A319/A320/A321

TITLE : AIR CONDITIONING - PRESSURE CONTROL AND MONITORING - INTRODUCE
MODIFIED CABIN PRESSURE CONTROLLER PN 20791

MODIFICATION No. : 27570K5548

This page transmits Revision No. 01 of Service Bulletin No. A320-21-1907.

NB6 21 1907 AAMA-A

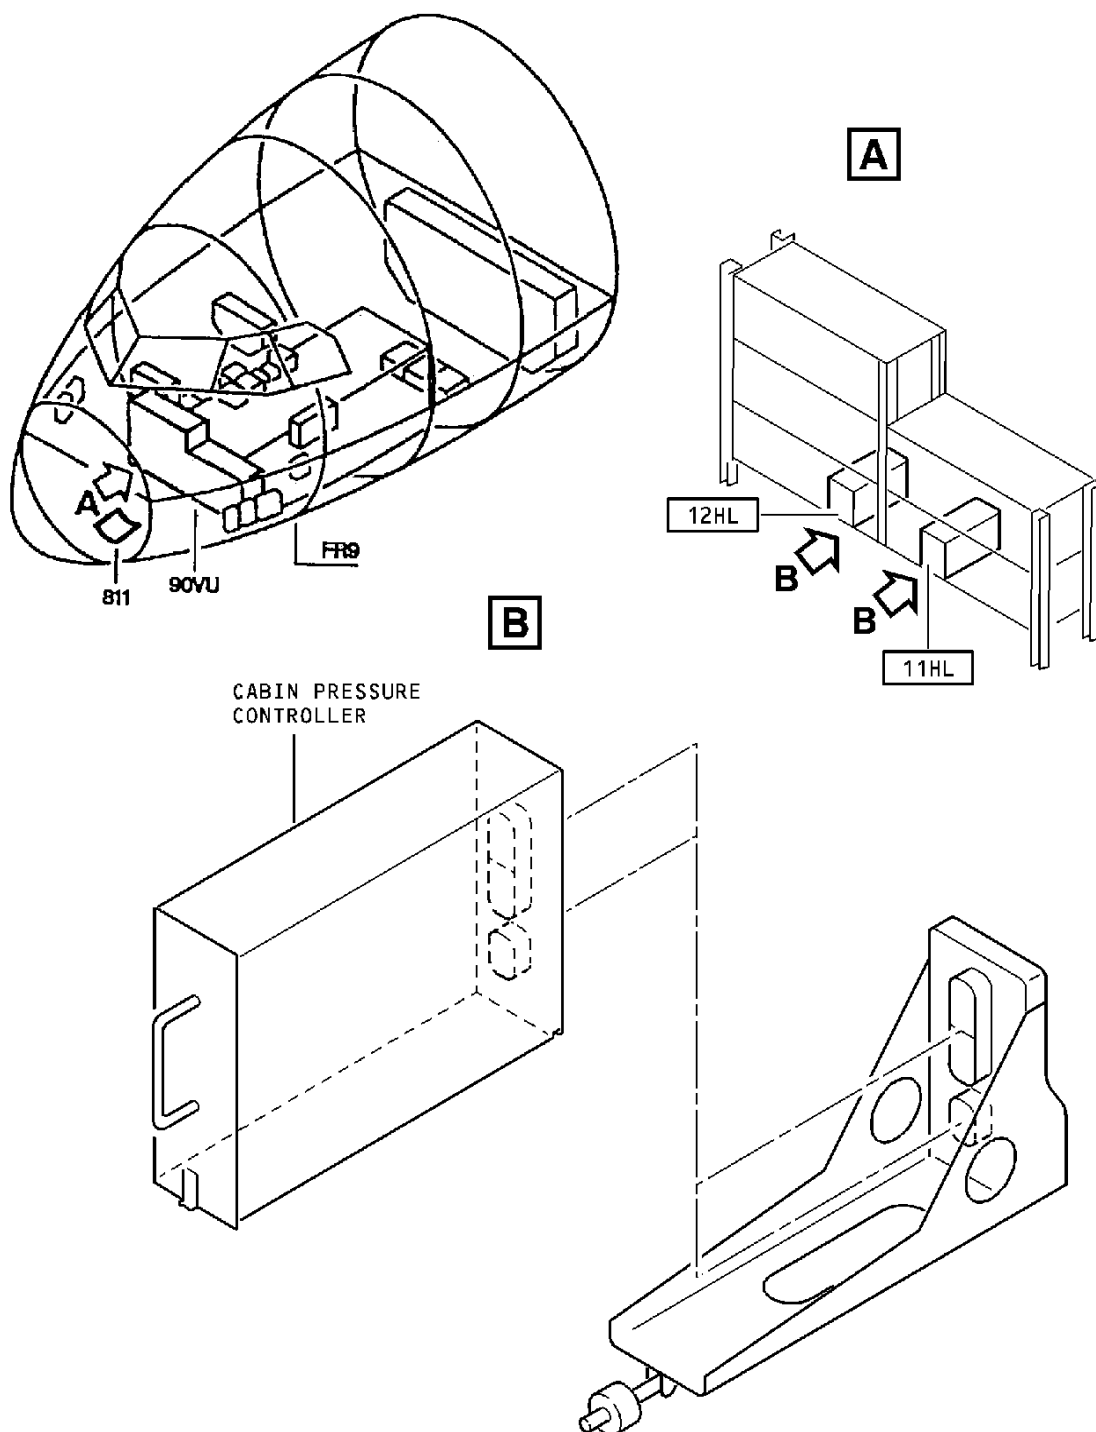
1 Cabin Pressure Controller

Old Part Number 9022-15702-9

New Part Number 20791-01AA (according to TA 5967/98)

Figure 1 Sheet 1

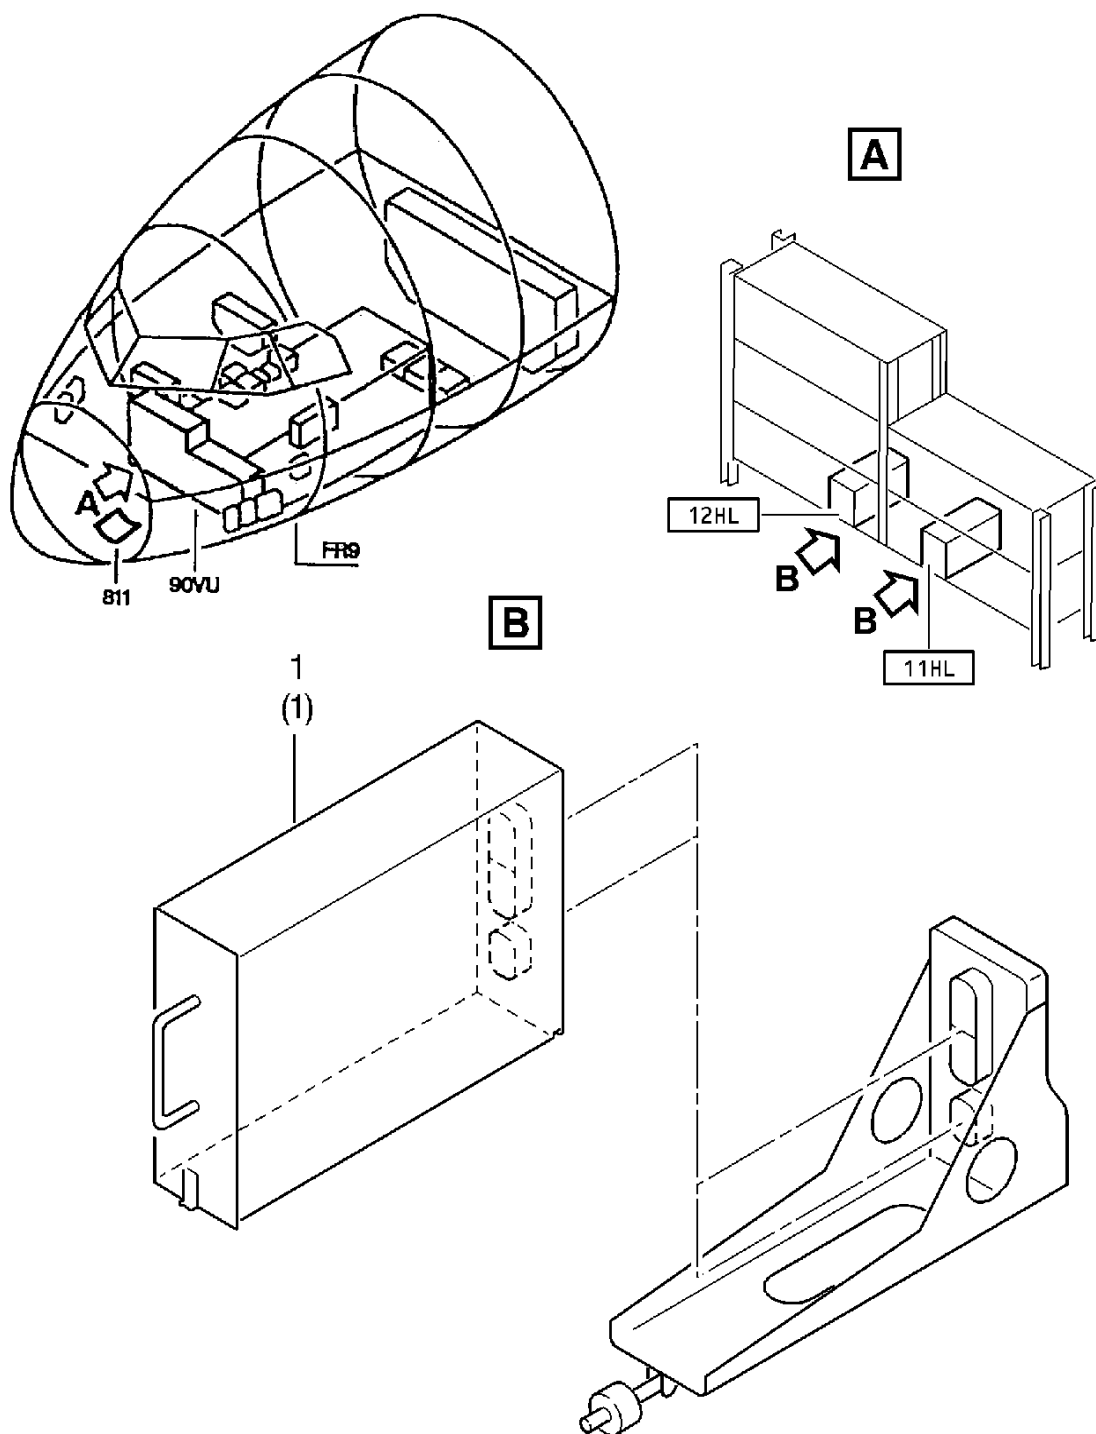
Refer to Figure 1

- (1) Remove the Cabin Pressure Controller, item (1), 11HL or 12HL (Refer to AMM: 21-31-34, P. Block 401).
- (2) Install the Cabin Pressure Controller 20791-01AA (according to TA 5967/98), item 1, 11HL or 12HL (Refer to AMM: 21-31-34, P. Block 401).
